Clondalkin

Draft Local Planning Framework

Chief Executive's Report for Proposed
Variation 1 to the County Development
Plan

November 2025

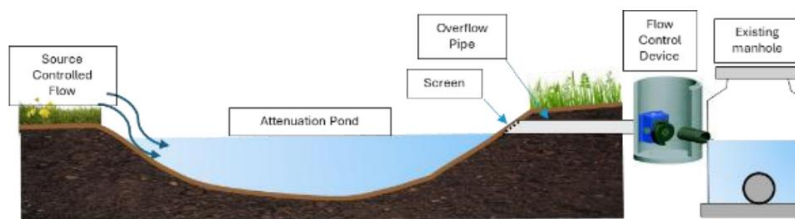
Observation 1, in summary, relates to Flood Risk Management, and in particular, the OPR states that ‘the Planning Authority should consider including the present-day flood risk mapping for Clondalkin to demonstrate the current predicted flood risk’. The full observation is as follows:

- Review opportunity sites with the Local Planning Framework area in the context of SuDS, where integrated and area-based provision of SuDS and green infrastructure can be incorporated in order to avoid reliance on individual site by site solutions; and
- Include the present-day flood risk mapping for Clondalkin as a distinct layer within the Strategic Flood Risk Assessment to demonstrate the current predicted flood risk.

Add 'Stormwater Management' section in A1.1:

'The site is predominantly greenfield and relatively large, providing excellent scope to implement an integrated and sustainable stormwater management strategy. Given its size, the area lends itself well to a masterplan-based SuDS design, where runoff from different development parcels can be managed collectively rather than through separate, site-by-site systems. A stormwater attenuation basin could be strategically located along the southern boundary near River Camac if the topography allows. This basin would serve as the main control feature, temporarily storing surface water before releasing it at a restricted rate—kept to the greenfield runoff equivalent or a practical minimum of 2 L/s in accordance with CIRIA guidance. A typical schematic for such site is illustrated below: Additionally, source control SuDS measures such as swales, rain gardens, and permeable paving should be incorporated within individual plots to slow, treat, and retain runoff close to where it falls. These measures will contribute to the overall network, reducing reliance on hard-engineered solutions and enhancing biodiversity and amenity. Exact location of attenuation site will depend on topographical and hydraulic assessment during later design stages.'

And add the following image in the 'Stormwater Management' section in A1.1:

Extract from Figure 5.9 of the LPF outlining the proposed permeability link from the Ninth Lock Road as far as Woodford Road.

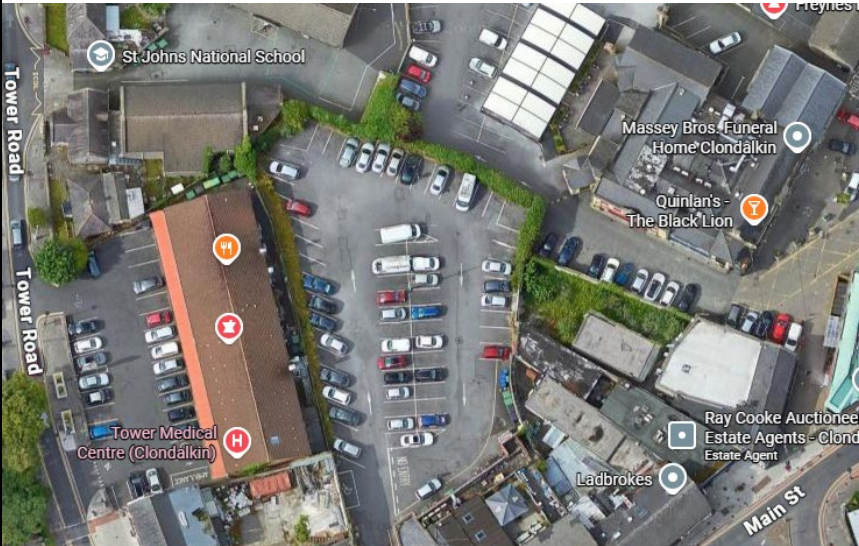
SD-C367-21 Janis Quane	Though submissions recognised that permeability does provide many benefits, it is not something which should be forced on long-established communities, particularly those with ongoing anti-social behaviour. A number of submissions stated there is an IPAS accommodation unit located along Monastery Road, and have raised concerns with those using this accommodation transitioning through the estate to get elsewhere.	 Image extracted from Figure 5.9 of the LPF, highlighting the potential connection between Monastery Heath and Woodford Estate, which would create shorter routes to schools, with the barrier to this connection shown as a circle. The ‘<i>Permeability Best Practice Guide</i>’ (NTA, 2012) is included as an objective in the LPF, and is therefore aligning with H7 Objective 3 in the County Development Plan which states: H7 Objective 3: <i>To support the principle of permeability schemes that provide improved connections between housing estates and their surrounds for walking and cycling, having regard to the National Transport Authority’s Permeability Best Practice Guide (2015) or any subsequent guidelines, including the provisions relating to permeability schemes and anti-social behaviour.</i>

The potential for this route is recognised as a long-term aspiration. It would provide for improved east-west connections within the LPF. Should mixed use or residential development come forward within the current industrial estate, which is provided for within the current town centre zoning, the identification of this route will ensure that opportunities to incorporate it into proposed development are not

lost. The link would also facilitate greater integration with development on the Ninth Lock Framework site, noting that it is an objective to have community facilities within the site along the Ninth Lock Road. The route would also facilitate access to the new BusConnects upgrades along New Nangor Road for those within Riversdale and Mayfield. The '<i>Permeability Best Practice Guide</i>' (NTA, 2012) is included as an objective in the LPF, and is therefore aligning with H7 Objective 3 in the County Development Plan which states: <i>H7 Objective 3: To support the principle of permeability schemes that provide improved connections between housing estates and their surrounds for walking and cycling, having regard to the National Transport Authority's Permeability Best Practice Guide (2015) or any subsequent guidelines, including the provisions relating to permeability schemes and anti-social behaviour.</i> It is recognised that the potential for anti-social behaviour, including safety and security, is a significant concern to the community. The NTA Guide provides examples and detail around best practice in the implementation of opening barriers to movement, the need for universal access and reducing the potential for anti-social behaviour would be included in design considerations. It is an objective within the LPF to:

SM4 Objective 2: <i>To ensure that proposed permeability links are designed in line with the NTA's best practice guidance and in such a way as to reduce the potential for anti-social behaviour, providing wide and inviting openings which are well lit.</i> In addition, a number of objectives in the LTP also make clear that local consultation with communities within which the permeability measures are proposed will be undertaken <u>before</u> implementing any proposed measures. <u>SM4 Objective 1</u> looks to '<i>support the permeability routes and links identified in Figure 5.9 and Table 5.4, <u>subject to further consultation</u>, which will enable quicker and safer access to schools, shops, places of work and social interaction in a pedestrian and cycle friendly environment</i>' There are also multiple objectives relating to the different categories of permeability routes in the LPF to ensure consultation prior to delivery: <i>SM5 Objective 1: To deliver the identified priority permeability routes, subject to local consultation, to facilitate improved connections to schools, increasing the safety of children currently using active travel and providing improved options for</i>

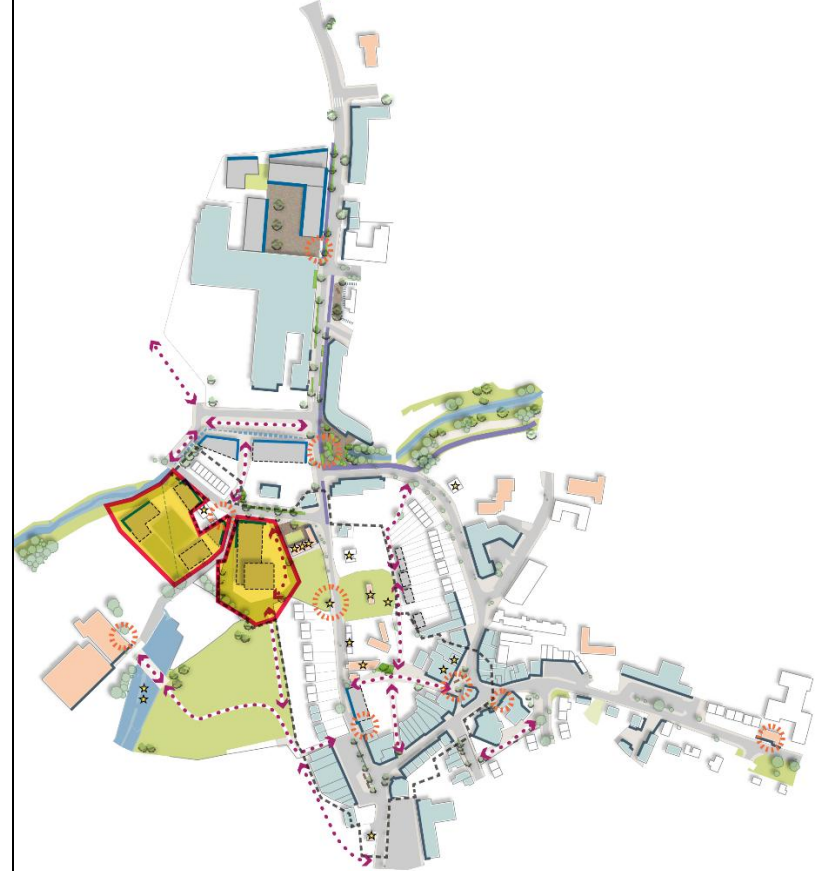
Mini Frameworks		
Submission No.	Submission Summary	CE response and recommendation
SD-C367-170 Clonmill Limited	Mill Centre Car Park BDP, acting on behalf of the Mill Shopping Centre Clondalkin, have made a submission on the mini framework relating to the Mill Centre car park. They acknowledge that the LPF will play a significant role in shaping the character and functionality of Clondalkin, welcoming some of the proposals described but highlighting issues with certain proposals outlined on the shopping centres lands. The submission focuses on the Mini Framework Site's proposal which interact with the Mill Centre lands and its impact on parking, access, servicing and maintenance for the centre. The submission states that a significant amount of development is proposed in the Mill Shopping Centres car park which is in private ownership. This includes the creation of new roads and pathways to connect to the Ninth Lock Framework, with the proposed new access route towards the Ninth Lock Framework (Section 8.5.2) impacting on key operations of the centre. The main issues are provided below: □ Proposed de-culverting and movement opportunities outlined will impact the operation and service of the centre.	CE Response: The LPF provides a planning framework for development within Clondalkin. As part of this, the Urban Design Strategy has identified lands, whether they are public or private, which may come forward for development in the future. These are identified as larger framework sites, mini-frameworks or opportunity sites. For each, key design parameters are identified to guide development should it come forward. The decision whether or not it comes forward is one for the relevant owner/s. The car park area within the Mill Shopping Centre is identified as a mini-framework site, recognising that there is potential for some development and the owner at any time could make a decision to bring this forward. Given its location, adjacent to the large framework site behind the shopping centre, there are clear opportunities to ensure that potential linkages between the sites are not lost. Such linkages would be primarily for walking and cycling – to provide easy access to new populations to the village and to the shopping centre itself and to make journeys shorter and more direct for those coming from the village side to the train station and to the new community. As such, it is considered very important to retain these potential linkages in the LPF.

redesign and creating short and long term disruption to the busy retail centre. Though the Mini framework plan proposes development opportunities with proposed units aligning to the path of the Camac, the location of them overshadows the proposed active route outlined in the LPF, the existing car park and the Mill Shopping Centre. This is turn will reduce the Mill's visibility and street presence on Tower Road and Old Nangor Road.	to placemaking within Clondalkin and to the environment around the shopping centre, it is recognised that there may be feasibility and other issues which make it difficult to achieve. The Council would be willing to work with the landowner to investigate whether there are any funding mechanisms which could help bring this forward. The submission is concerned at the estimated loss of car parking spaces that development may necessitate. Should development come forward, consideration would have to be given to the rationalisation of car parking, ensuring that it continues to meet the needs of those using the shopping centre. The mini-framework is not requiring development on the site but it is recognising that there may be potential on the site for development and in that regard, it is setting out design parameters to guide development in the event that a planning application comes forward. It is also noted that SM5 Objective 3 needs to be changed for clarity purposes: <i>To ensure that new development and key lands maximise the potential for active travel connectivity between the site to the village centre, local services and schools and to public transport'</i> CE Recommendation: Amend SM5 Objective 3:

From <i>‘To ensure that new development and key lands maximise the potential for active travel connectivity between the site to the village centre, local services and schools and to public transport’</i> To <i>‘To ensure that new development and key lands maximise the potential for active travel connectivity between areas outside the village centre, including the Ninth Lock Framework site, to the village centre, local services and schools and to public transport.’</i> And Amend Figure 8.32 on page 104 to remove reference to ‘vehicle movement’ and to illustrate more clearly the long term high capacity public transport route, as identified in the adopted County Development Plan. And Include the identification of the permeability links in the Figure 8.32 Key, identified as ‘n’ and ‘o’ between the Ninth Lock Framework site and the Mill Centre site, as shown on the revised map below.
--	--	--

-  Active Movement
-  Active travel route
-  High Capacity Public Transport Reserve
-  Future Permeability
-  Active Frontage

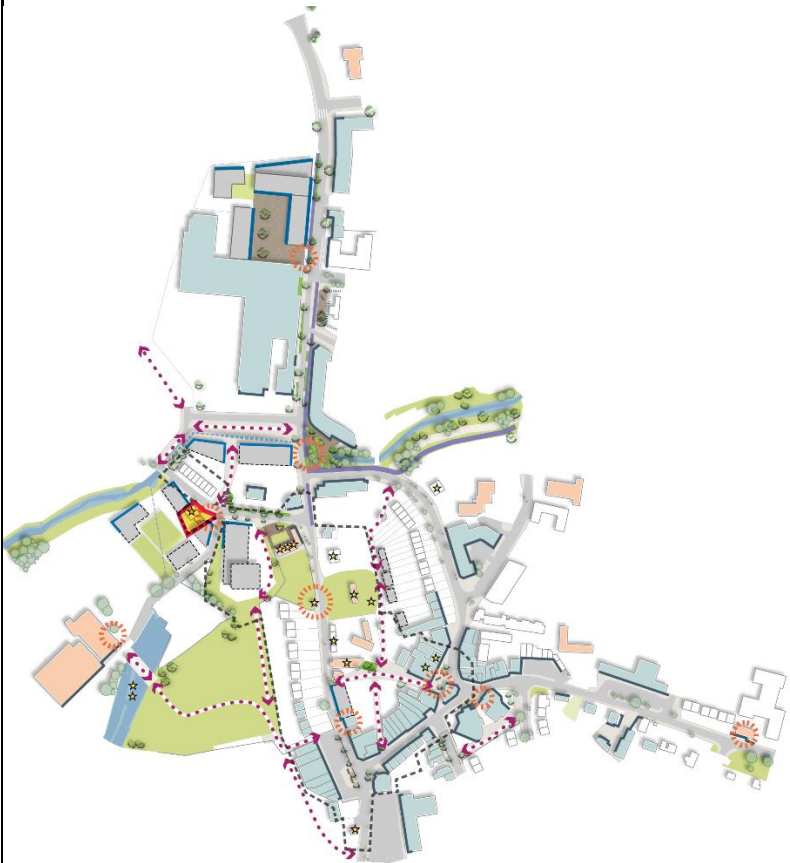
SD-C367-55 Cllr Francis Timmons	Old Nangor Road Infill Site The submission refers to Figure 8.15 on page 83 of the Local Planning Framework and requests that the image makes clear whether the Old Nangor Road is one or two way.	CE Response: The submission is noted. For clarity, it is noted that Figure 8.15 is on page 93. The image on Old Nangor Road is intended to convey that it remains two way. However, it is acknowledged that the graphics could be improved to make this more clear. It is also noted that the site location of the Old Nangor Road Mini Framework in Figure 8.13 is incorrect and needs to be corrected. CE Recommendation: Amend Figure 8.13 on page 93 to illustrate the correct location of the Old Nangor Road Mini Framework location.
--	---	---

And amend Figure 8.15 on page 93 to illustrate more clearly that Old Nangor Road is two way.
